ECE/TRANS/WP.29/2010/35
18 December 2009

Proposal for the 01 series of amendments to Regulation No. 123
(Adaptive front-lighting systems)

Submitted by the Working Party on Lighting and Light-Signalling */

Figure 1

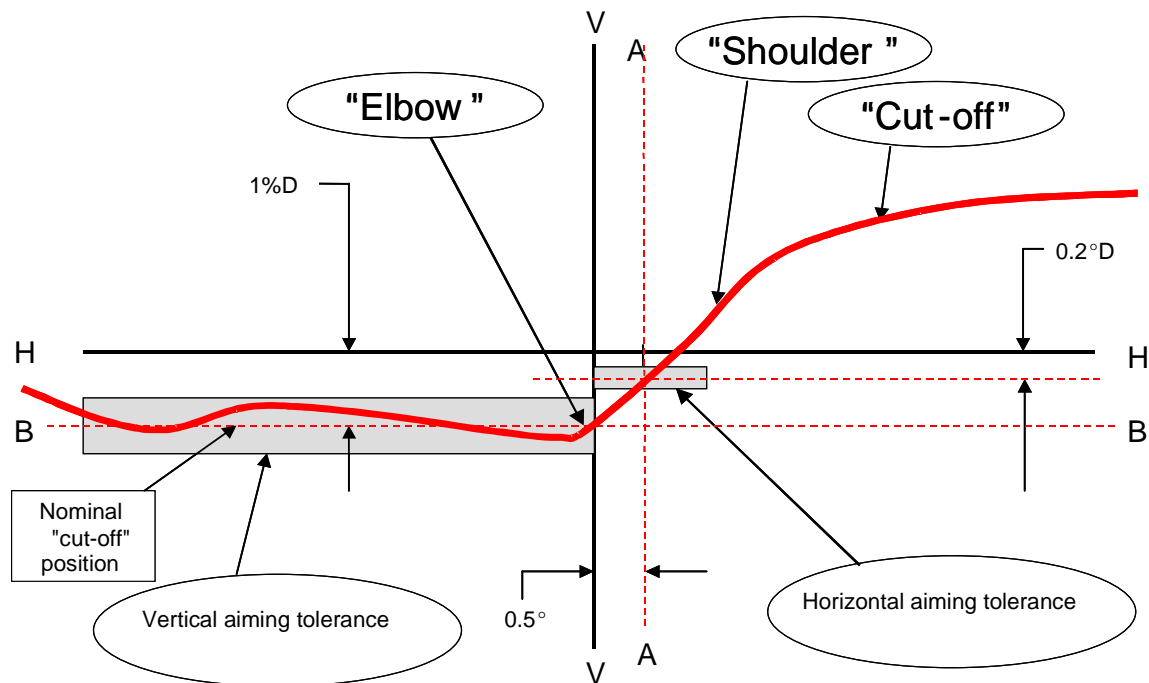
Paragraphs 2.2. and 2.3., amend to read:

- "2.2. The beam shall be visually aimed by means of the "cut-off" (see figure 1 below). The aiming shall be carried out using a flat vertical screen set up at a distance of 10 m or 25 m (as indicated in section 9 of Annex 1) forward of the headlamp and at right angles to the H-V axis. The screen shall be sufficiently wide to allow examination and adjustment of the "cut-off" of the passing beam over at least 5° on either side of the V-V line.
- 2.3. for vertical adjustment: the horizontal part of the "cut-off" is moved upward from below line B and adjusted to its nominal position one per cent (25 cm) below the H-H line;

Note: The scales are different for vertical and horizontal lines."

Figure 1: Measurement of "cut-off" quality

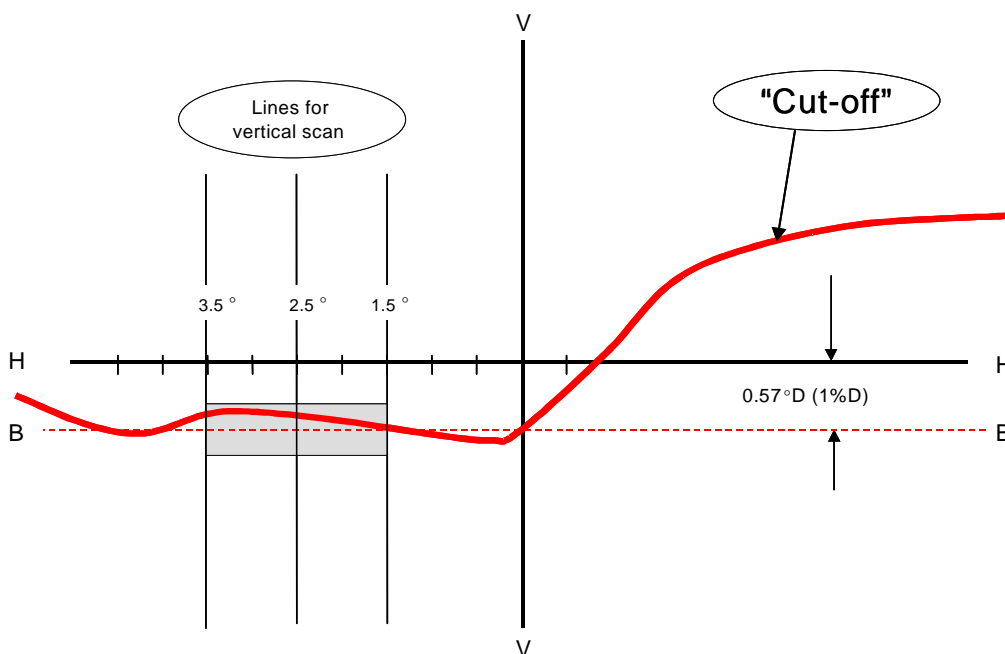
Insert new paragraphs 3 to 3.2., to read:

"3. VERTICAL AND HORIZONTAL ADJUSTMENT

If the "cut-off" complies with the quality requirements of paragraph 2. of this annex, the beam adjustment may be performed instrumentally.

Figure 2: Instrumental vertical and horizontal adjustment- horizontal line scan method
 (b) The "3 line" method (see figure 3 below)

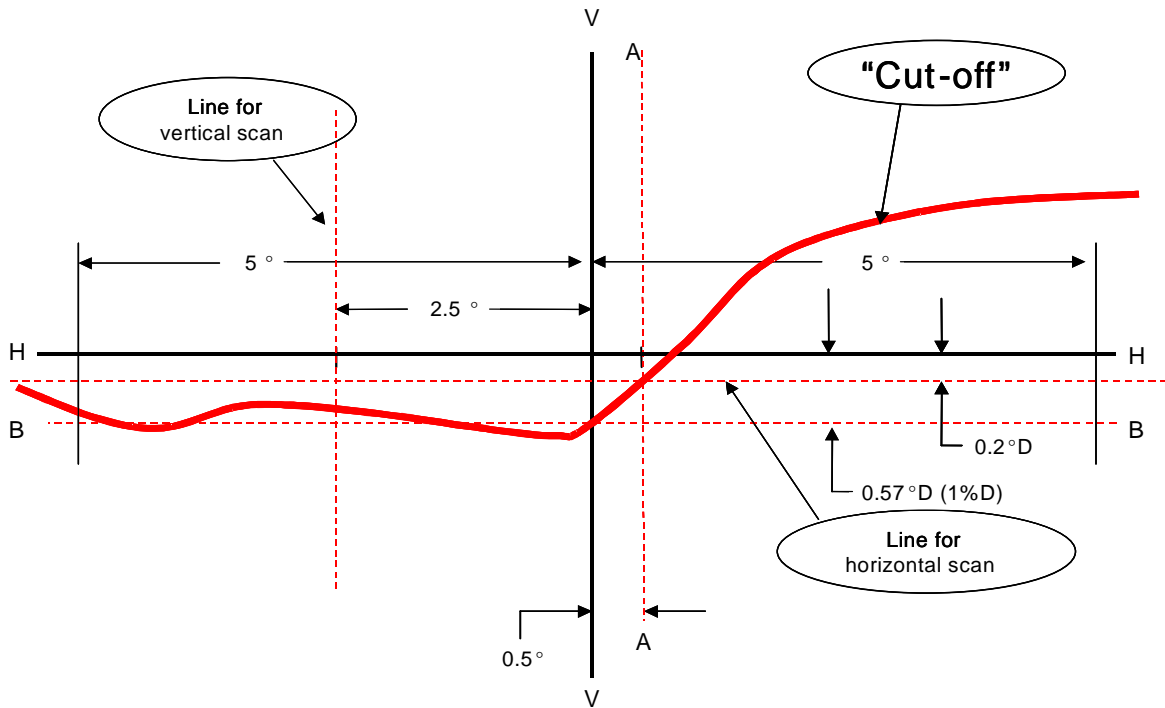
3.2. Horizontal adjustment

- (a) The "0.2 D line" method (see figure 2 below).

A single horizontal line at 0.2° D shall be scanned from 5° left to 5° right after the lamp has been aimed vertically. The maximum gradient "G" determined using the

formula $G = (\log E_{\beta} - \log E_{(\beta + 0.1^{\circ})})$ where β is the horizontal position in degrees, shall not be less than 0.08.

The inflection point found on the 0.2 D line shall be positioned on the line A.

Figure 3: Instrumental vertical and horizontal adjustment-three line scan method "

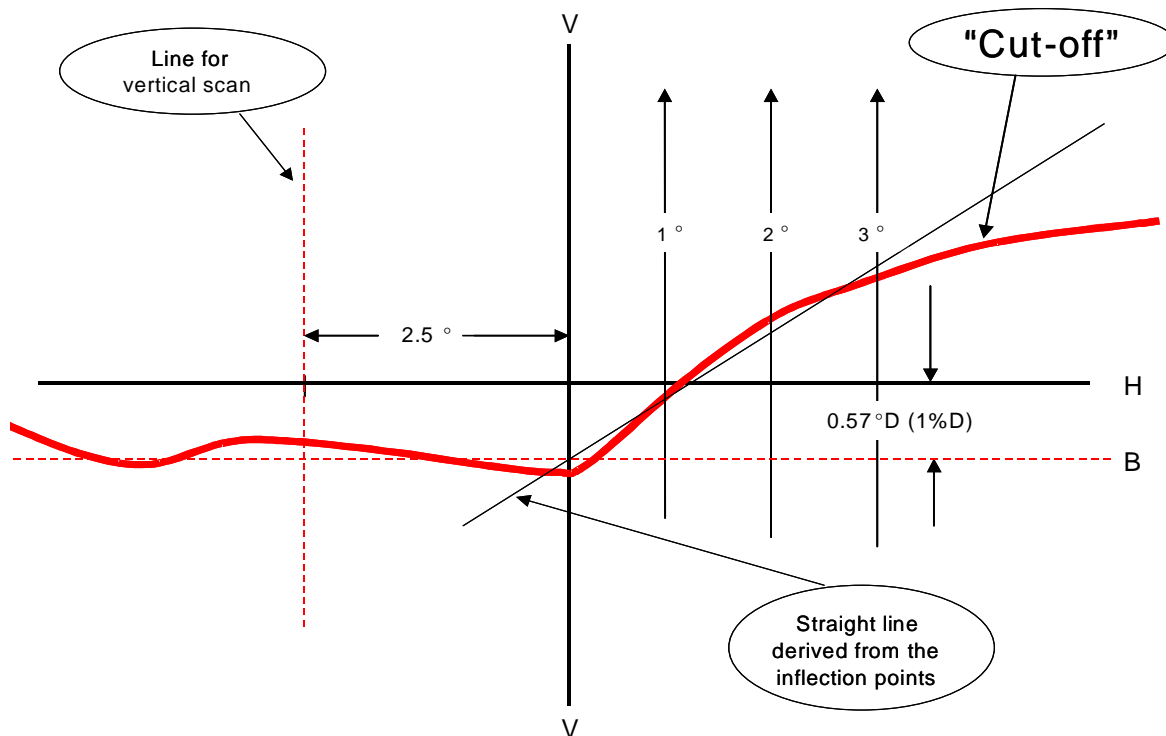
Three vertical lines shall be scanned from 2° D to 2° U at 1°R, 2°R, and 3°R after the lamp has been aimed vertically. The respective maximum gradients "G" determined using the formula:

$$G = (\log E_{\beta} - \log E_{(\beta + 0.1^{\circ})})$$

where β is the vertical position in degrees, shall not be less than 0.08. The inflection points found on the three lines shall be used to derive a straight line. The intersection

of this line and the line B found while performing vertical aim shall be placed on the V line.
